## **FCC Class II Permissive Change Application Letter**

Product name : Roku TV Smart Projector

FCC ID:2BU2U-K200

external  
bracket and  
silk screen

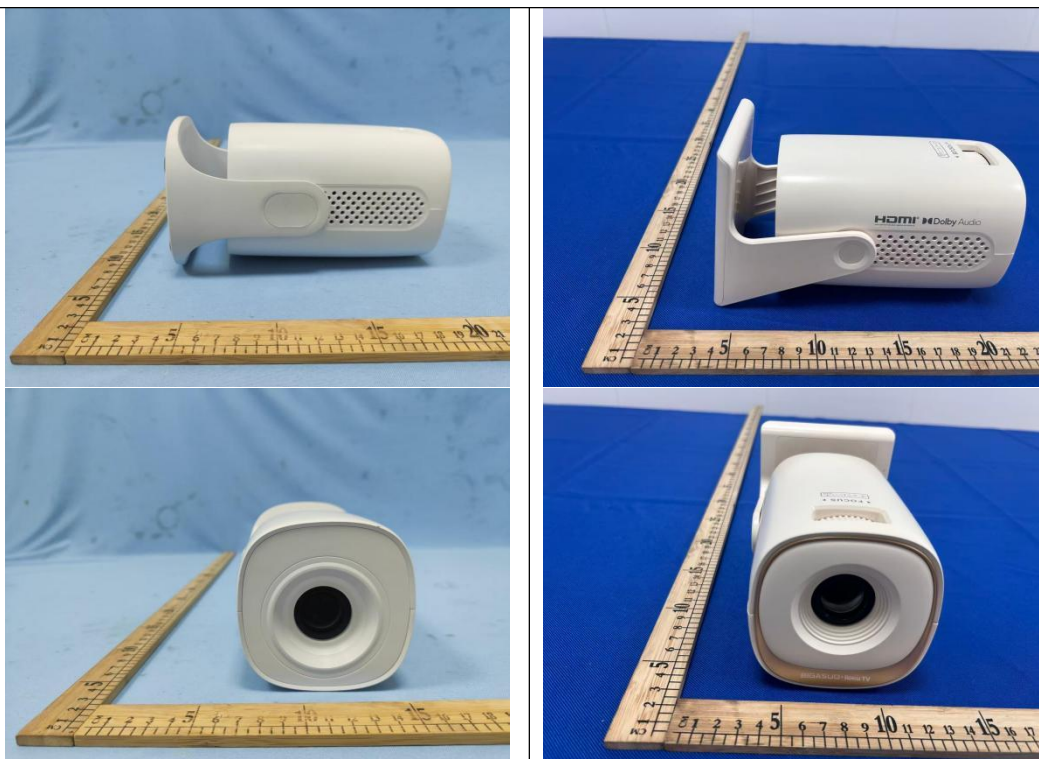
Change Contents: The external frame and screen printing design have been adjusted;  
therefore, this revision introduces the new model numbers "BRP-PT210, BRP-PT220, and  
BRP-PT230" to the original report lineup:

\*Based on the original report's model K200, BRP-PT210 external bracket has been modified, with added silk screen printing; and the report includes radiated spurious emissions for 30-1000MHz difference testing; The differences between models BRP-PT220 and BRP-PT230 and model BRP-PT210 lie in the name and color.
